Product Change Notice (PCN)

PCN Number: PCN-0456972R-02

Product(s) Affected: *PJ-036 Series: PJ-036D & PJ-036DH (part shown on PCN is PJ-036DH –1.3mm Center Pin)*

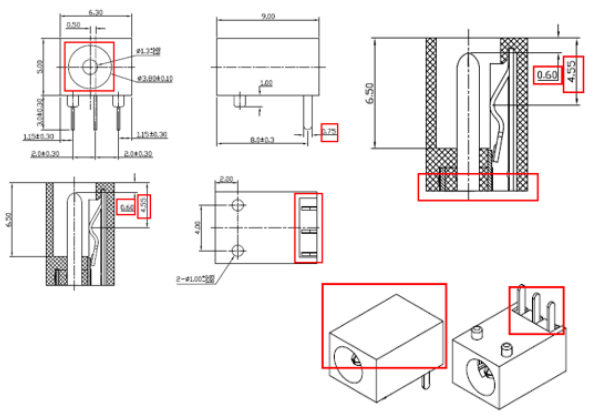
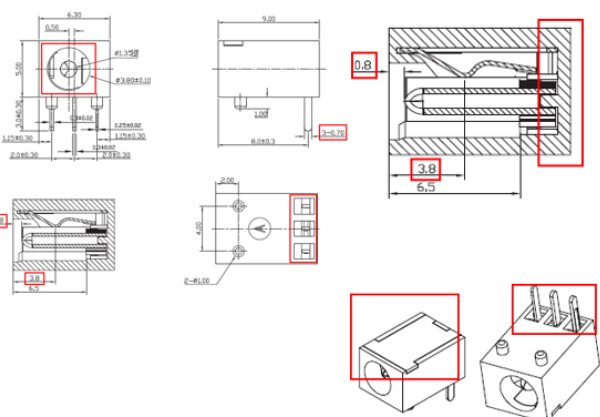
Description of Change: *Product re-engineered for improved manufacturability and production yield. image below for reference and check Same Sky website for updated drawing. Cosmetic differences may be visible but will not affect the form fit and function of the product. New back cover to prevent exposed leads (not visible on product drawing). Please check updated samples before production approval.*

DESCRIPTION	MATERIAL	PLATING/COLOR
center pin	brass	silver
terminal 1	brass t=0.25	silver
terminal 2	SUS301 t=0.25	silver
terminal 3	brass t=0.25	silver
housing	PA10T (UL94V-0)	black

DESCRIPTION	MATERIAL	PLATING/COLOR
center pin	brass	silver
terminal 1	brass t=0.30	silver
terminal 2	bronze t=0.25	silver
terminal 3	brass t=0.30	silver
housing	PA66 (UL94V-0)	black
cover	PA66 (UL94V-0)	black
